To: T10 Technical Committee  
From: Rob Elliott, HP (elliott@hp.com)  
Date: 15 September 2004  
Subject: 03-240r6 SAS-1.1 Internal wide connector and cable

### **Overview**

### **Suggested changes**

**[Figure 2 — Internal wide cabled environment - controller to backplane - symmetric cable](#)**

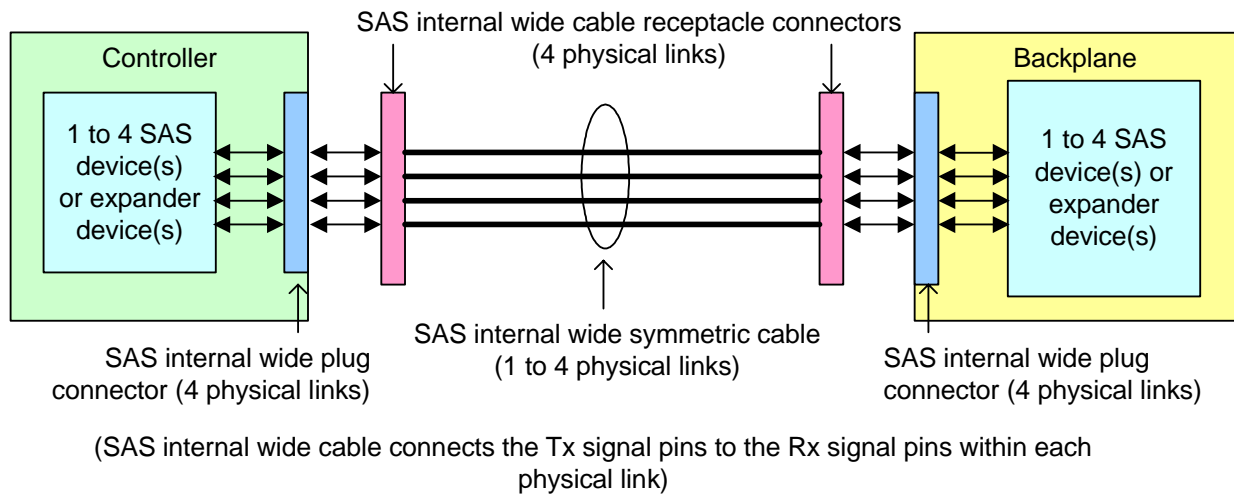
[Figure 2 shows a schematic representation of the cables and connectors defined in this standard for the internal wide cabled environment attaching a controller to a backplane using a symmetric cable.](#)

[The SAS internal wide symmetric cable provides one to four physical links, and may be used as any combination of wide links and narrow links \(see 4.1.3\) using those physical links.](#)

[The internal wide cable receptacle connectors have different pinouts for the controller end and the backplane end so one end's Tx signals are attached to the other end's Rx signals.](#)

**[Figure 3 — Internal wide cabled environment - controller to controller - symmetric cable](#)**

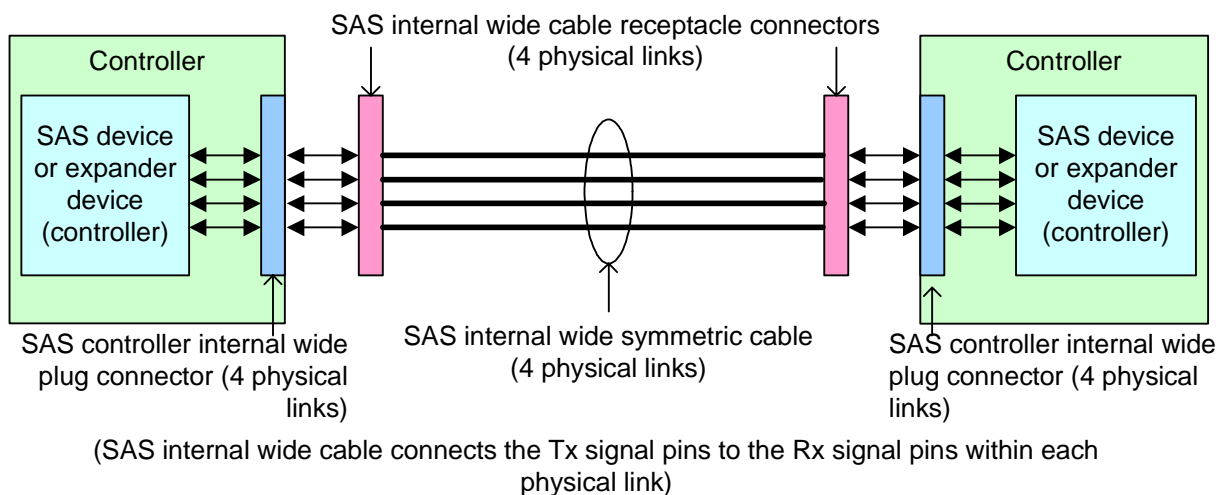
[Two controllers may also be attached together with a symmetric cable that provide 4 physical links if all four physical links are used by each controller, since one end's physical link 0 is attached to the other end's physical link 3. Figure 3 shows the internal wide cabled environment attaching a controller to a controller using a symmetric cable.](#)

**Figure 4 — Internal wide controller-based fanout cable environment**

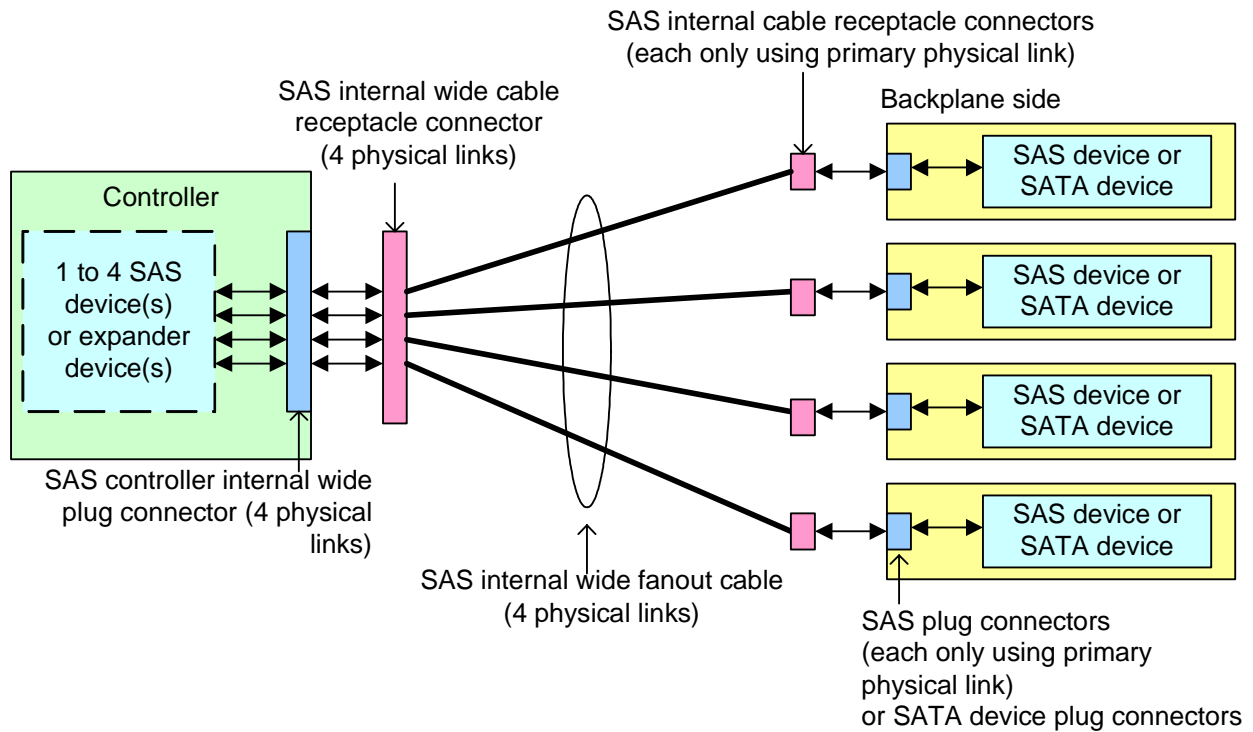
[Figure 5 shows a schematic representation of the cables and connectors defined in this standard for the internal wide cabled environment using a controller-based fanout cable.](#)

(the cable connects the Tx signal pins to the Rx signal pins within each physical link)

**Figure 5 — Internal wide backplane-based fanout cable environment**

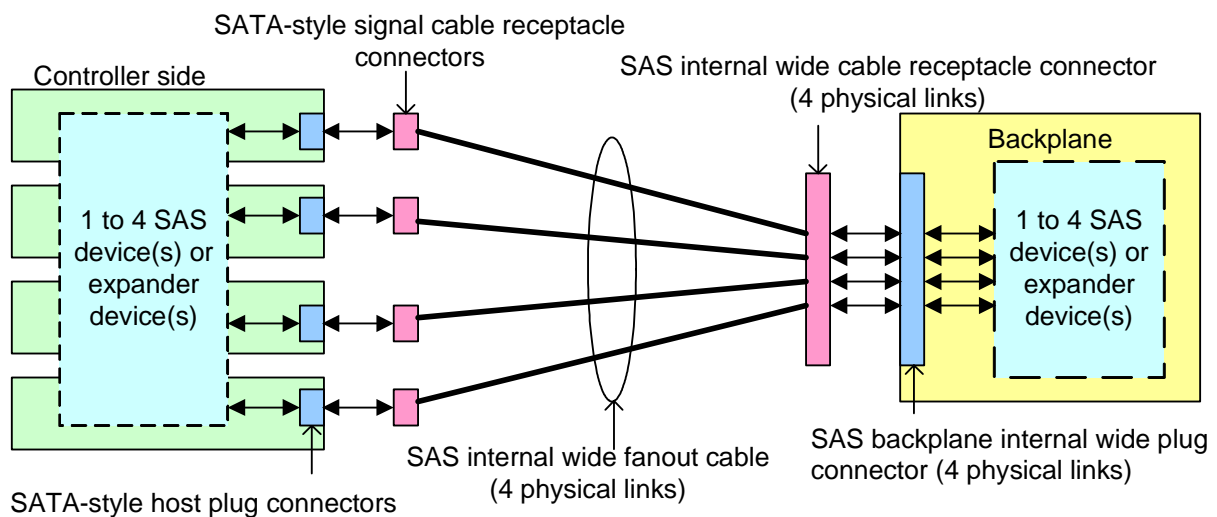
[Figure 5 shows a schematic representation of the cables and connectors defined in this standard for the internal wide cabled environment using a backplane-based fanout cable.](#)

(the cable connects the Tx signal pins to the Rx signal pins within each physical link)

**Figure 6 — SAS internal wide cable attaching controller to backplane**

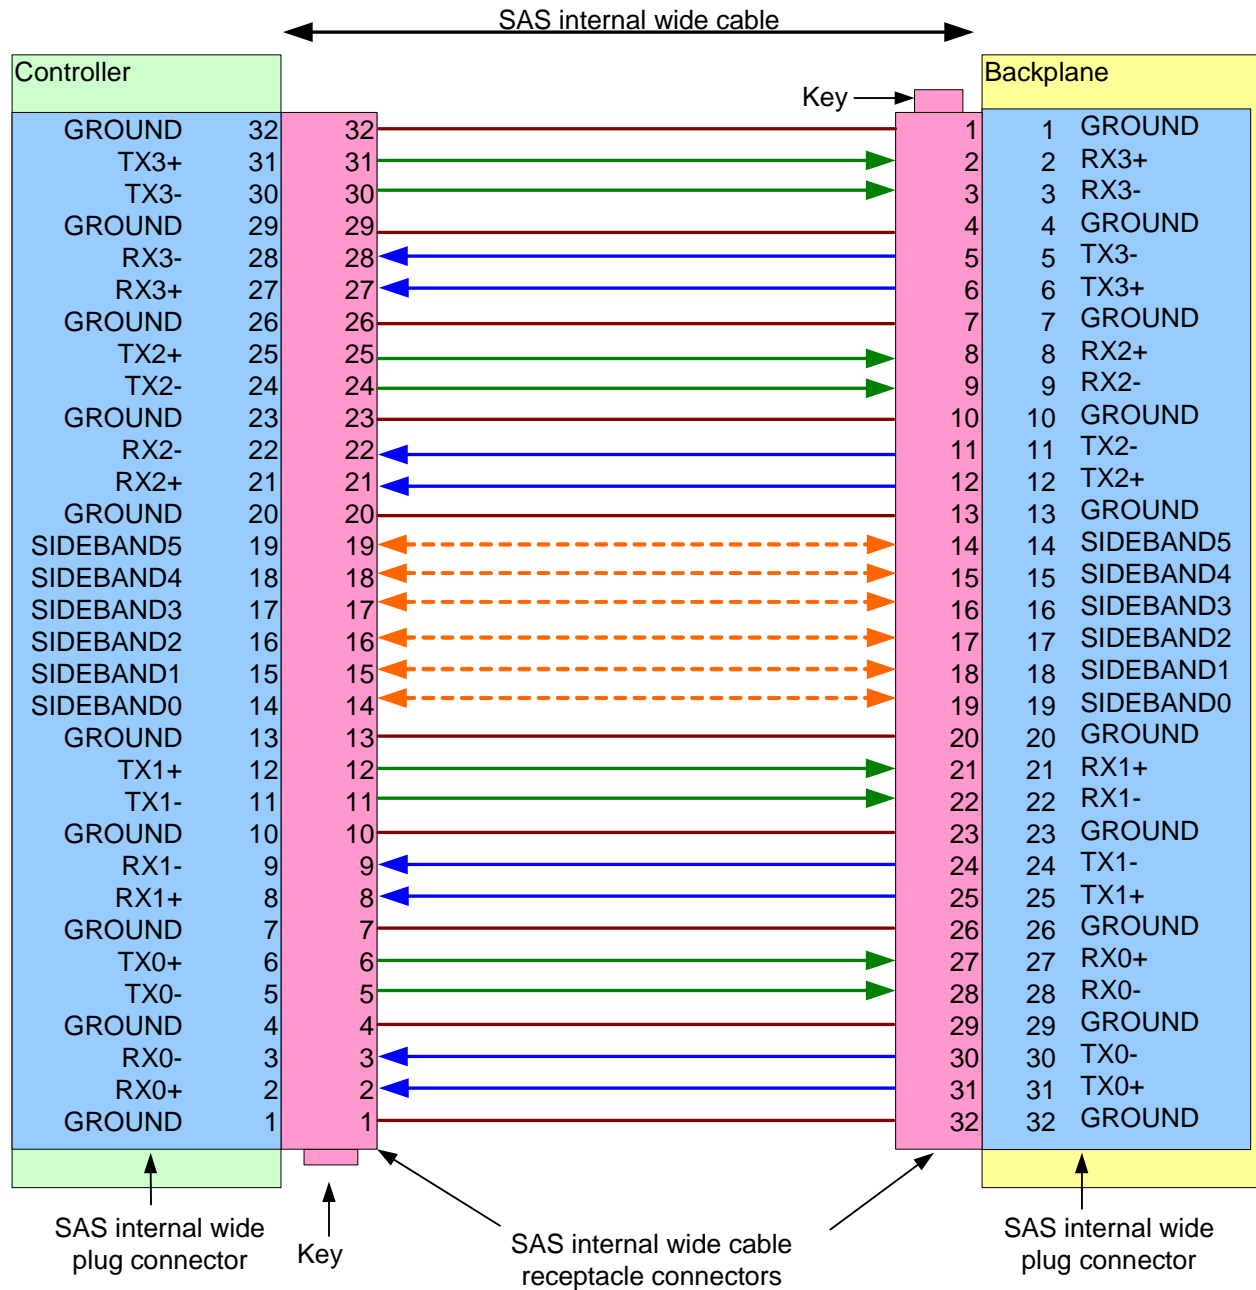
Figure 6 shows the SAS internal wide cable being used to attach a controller to a backplane.

NOTE 2 - For controller to backplane uses, up to four physical links may be used. SIDE BAND signals on the controller are attached to the corresponding SIDE BAND signals on the backplane (e.g., SIDE BAND0 of the controller is attached to SIDE BAND0 of the backplane).

**Figure 7 — SAS internal wide cable attaching controller to controller**

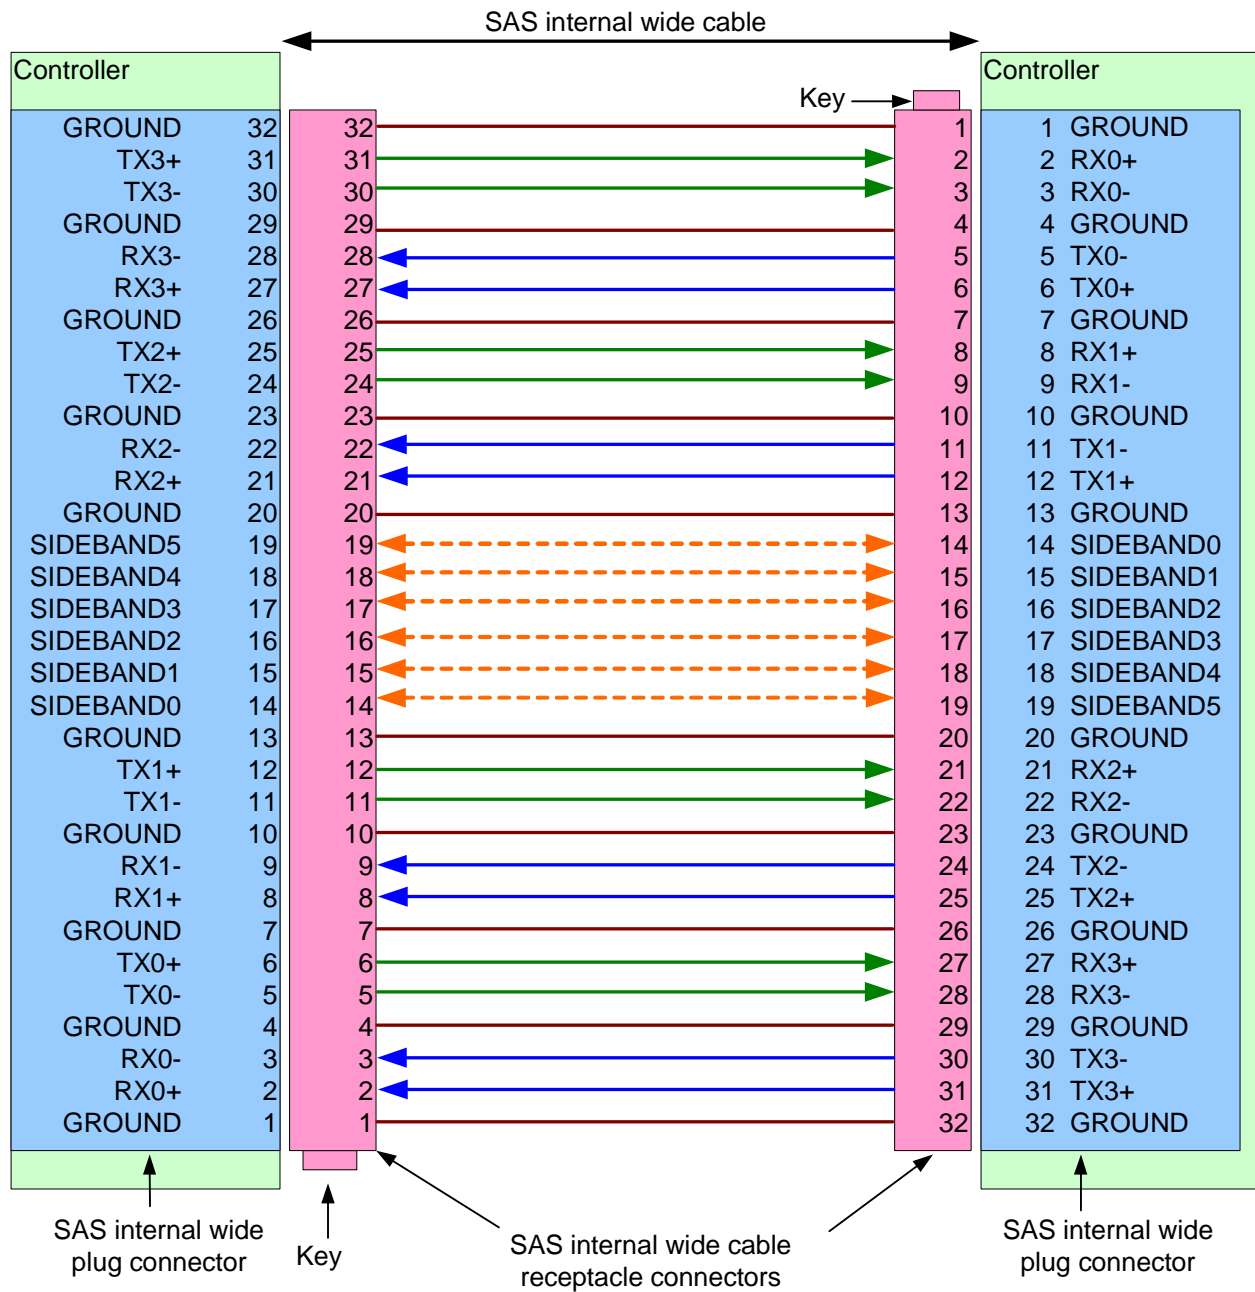
[Figure 7 shows the SAS internal wide cable attaching two controllers.](#)

NOTE 3 - For controller to controller uses, all four physical links should be used, because one controller's physical link 0 is attached the other controller's physical link 3. If both controllers used only physical link 0, they would not communicate.

NOTE 4 - For controller to controller uses, SIDEBAND signals on one controller are not attached to their corresponding SIDEBAND signals on the other controller (e.g. SIDEBAND0 of one controller is attached to SIDEBAND5 of the other controller).

Figure 8 — SAS internal wide controller-based fanout cable

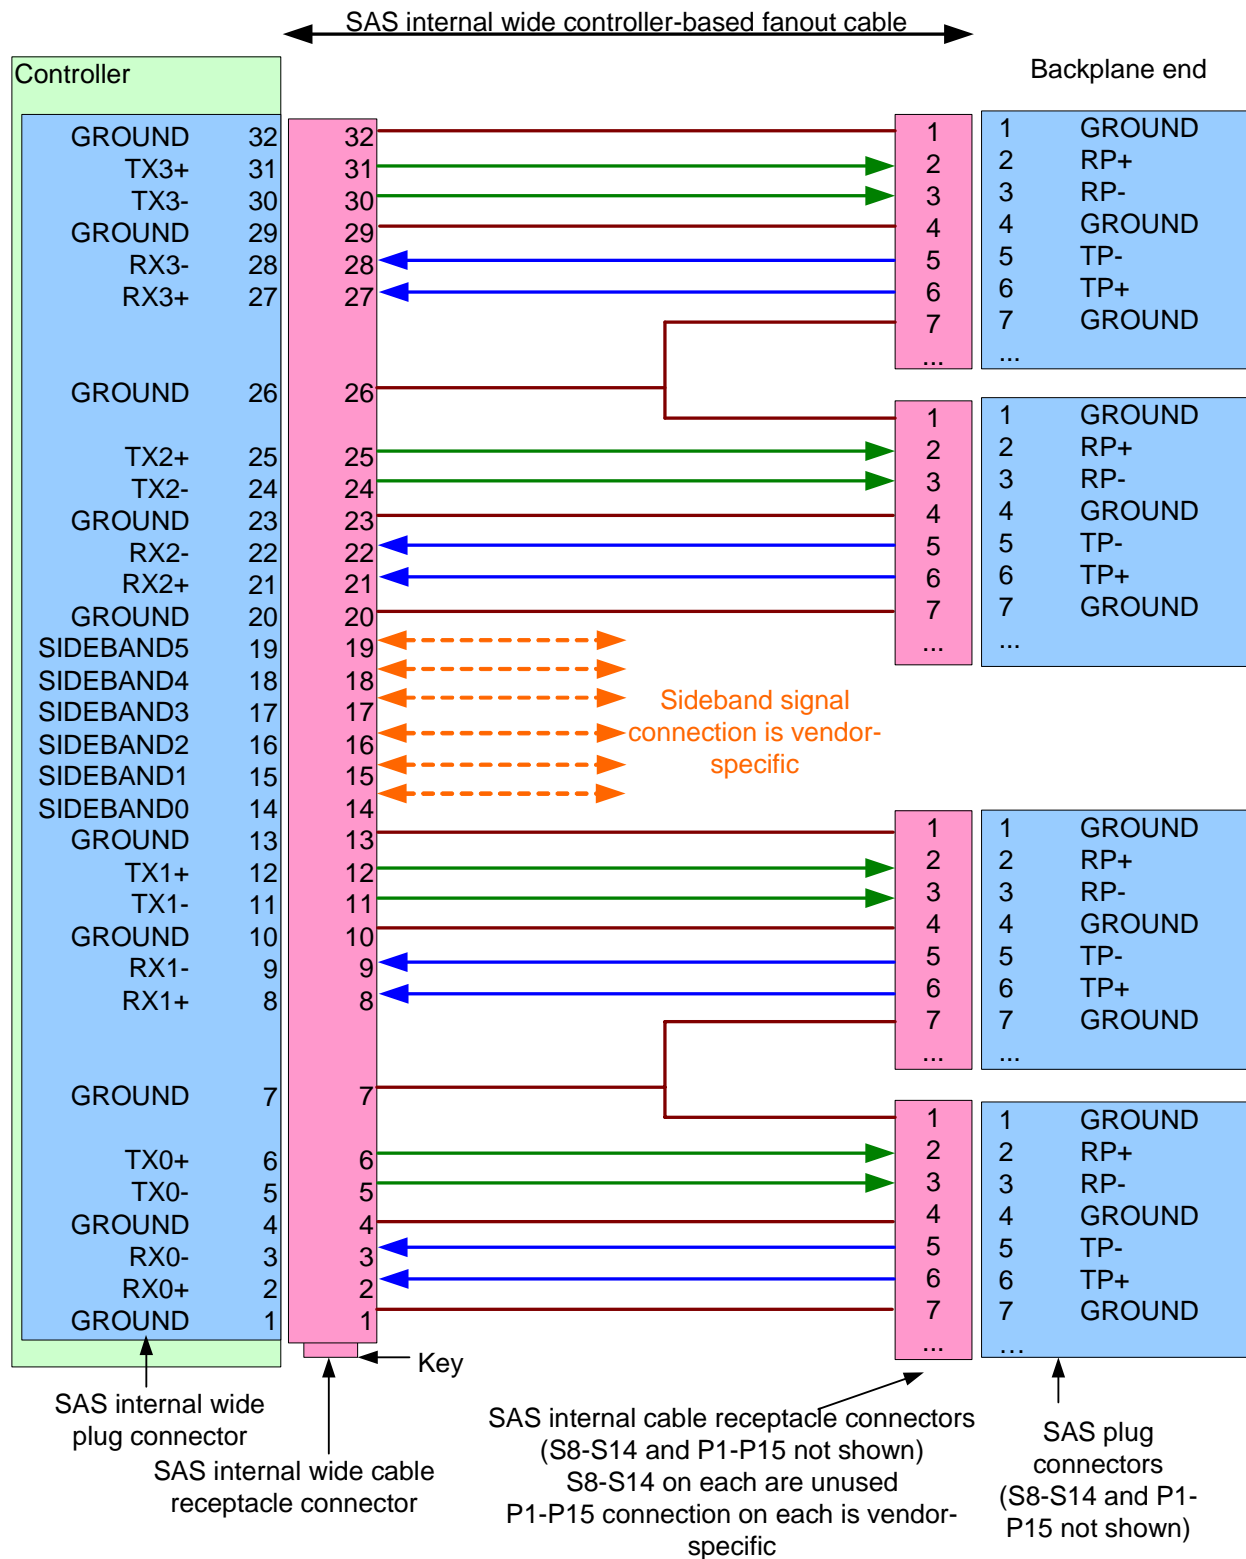
Figure 8 shows the SAS internal wide controller-based fanout cable.

**Figure 9 — SAS internal wide backplane-based fanout cable**

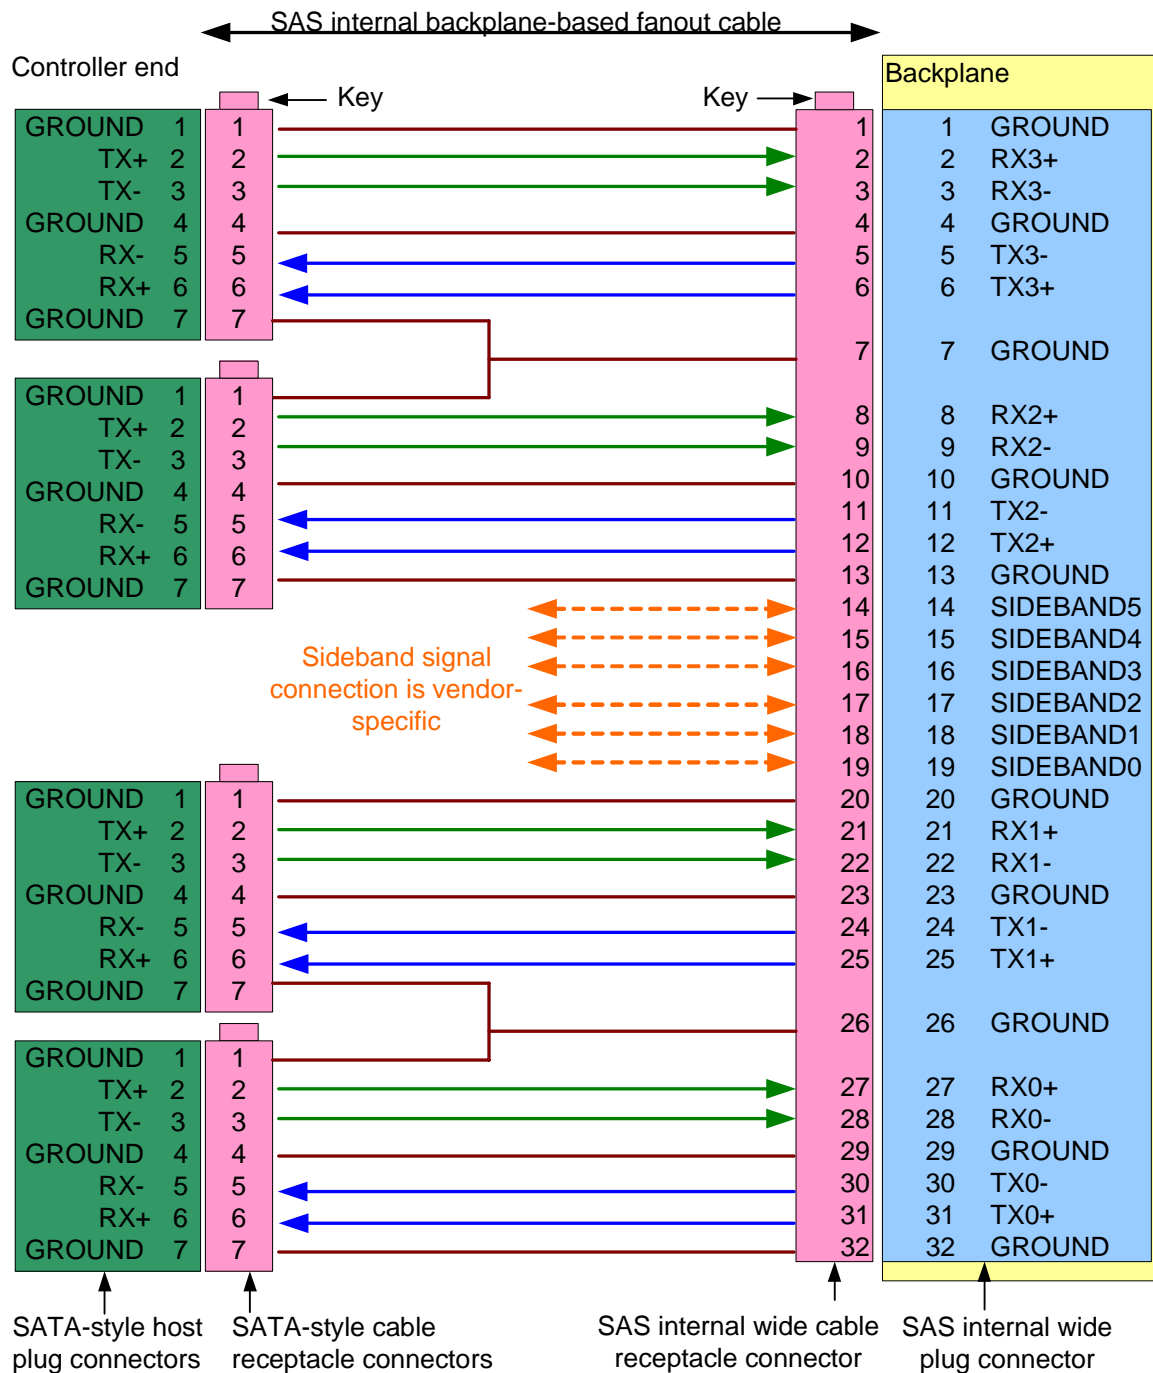
[Figure 9 shows the SAS internal wide backplane-based fanout cable.](#)
